DOGGER BANK SOUTH OFFSHORE WIND FARM PROJECTS (DBS PROJECTS) DEADLINE 3 SUBMISSION

DOGGER BANK OFFSHORE WIND FARM PROJECT 1 PROJCO LIMITED, DOGGER BANK OFFSHORE WIND FARM PROJECT 2 PROJCO LIMITED AND DOGGER BANK OFFSHORE WIND FARM PROJECT 3 PROJCO LIMITED

Appendix 1 - Submission made by Hornsea Project 1 to Deadline 1 in relation to the Examination of the Hornsea Project 2

Hornsea Project One Deadline 1 Submission

Figure 1: Diagram showing the Project One substation infrastructure illustrating full utilisation of the Order Limits for the substation.

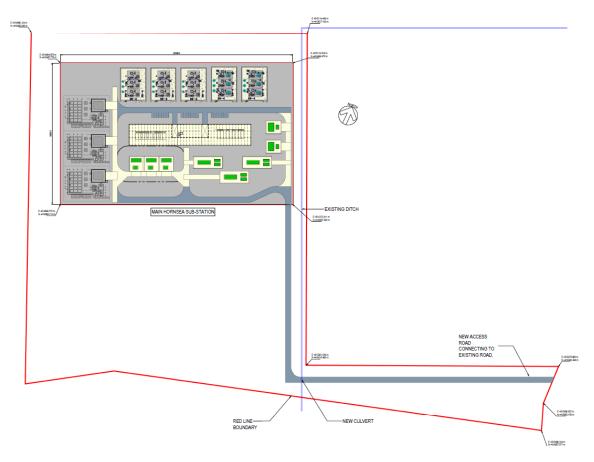
- 8.7 There is a particular conflict between the Project Two proposals and the approved Project One substation, shown on Overlap Plan 1. Plot 506 in part seeks permanent acquisition of a significant part of the Project One substation land where Project One already has powers to acquire the land permanently. (The remainder of Plot 506 seeks permanent acquisition of land which Project One has temporary use powers for the purpose of constructing the neighbouring Project One substation.) In addition, Plot 505 seeks temporary occupation of the majority of the Project One substation land where Project One already has powers to acquire the land permanently. Finally, Plots 503 and 507 seek powers of temporary occupation and acquisition of permanent rights over land where, again, Project One already has powers to acquire the land permanently.

- 8.8 Since the grant of the Project One Order, Project One has significantly progressed its detailed design phase for the onshore substation. The designs show that Project One requires the full extent of the consented Order Limits designated for permanent use for the substation. Figure 1 below provides a visualisation of the Project One substation showing how the electrical infrastructure will fill the full extent of the Project One Order Limits at the substation site.

- 8.9 The Statement of Reasons does not explain why Project Two requires permanent acquisition of part of this land, as part of Plot 506, in the light of its intended use for Project One (paragraph 5.2.5, for example, does not address the issue²). Given Project One's proposed use and the fact that it has already secured the land by agreement (and, as a fall back, successfully secured powers of compulsory acquisition under the Project One Order), the Project One Companies' request the compulsory powers sought are not granted and that this land is removed from the Book of Reference. If this is not done the uncertainty created by Project Two having competing powers of compulsory acquisition over part of its main substation site would adversely affect delivery of the project and would cause serious detriment to the undertakings of the Project One Companies given that all three statutory undertakers are relying on the delivery of the substation for delivery of the three NSIPs within the Project One Order.

- 8.14 **Proposed solution:** The Project One Companies require the removal of Plots 503, 505, 507 and the northern part of Plot 506 (shown separately on Overlap Plan 1) from the Project Two Development Consent Order and the Book of Reference.
